Promulgation Details for 1 RCNY 3610-02

NOTICE OF ADOPTION OF RULE

CHAPTER K4
MODIFICATIONS TO ASME A17.1S-2005
SAFETY CODE FOR MACHINE-ROOM-LESS (“MRL”) ELEVATORS

Figure Q-2

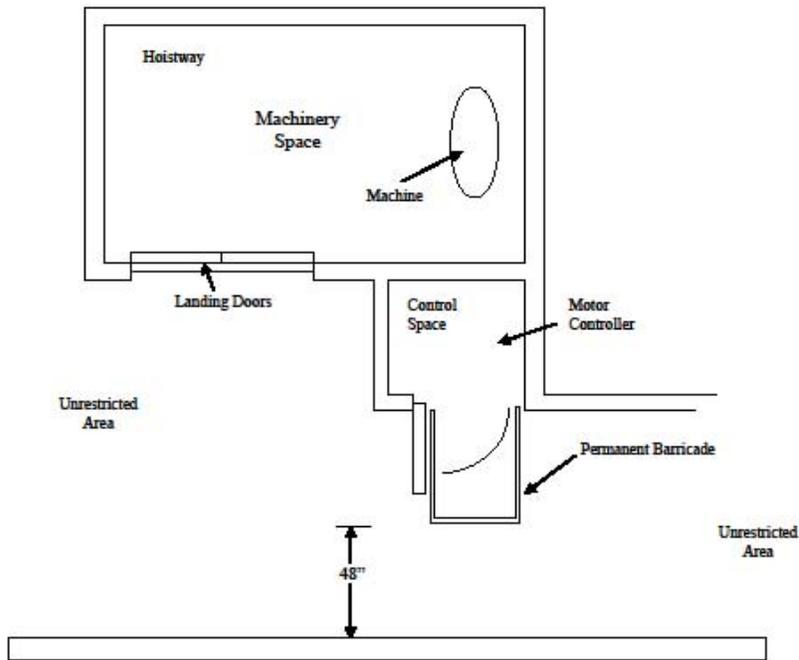
(d) A control space and machinery space for elevators must only be located where working clearances required for the control space will not impede upon the path of travel in unrestricted areas. Where the elevator control space is located in a path of travel in an unrestricted area, a clear path of travel parallel to the control space must not be less than the required working clearance plus 1219 mm (48 in) perpendicular to the control space. A permanent barricade needed to establish the working clearances for the control space must be accessible to elevator personnel from the control space. The barricade must be deployed whenever the doors to the control space are in the open position. See figure Q-2.

Delete and replace Figure Q-2 with the following new Figure Q-2:
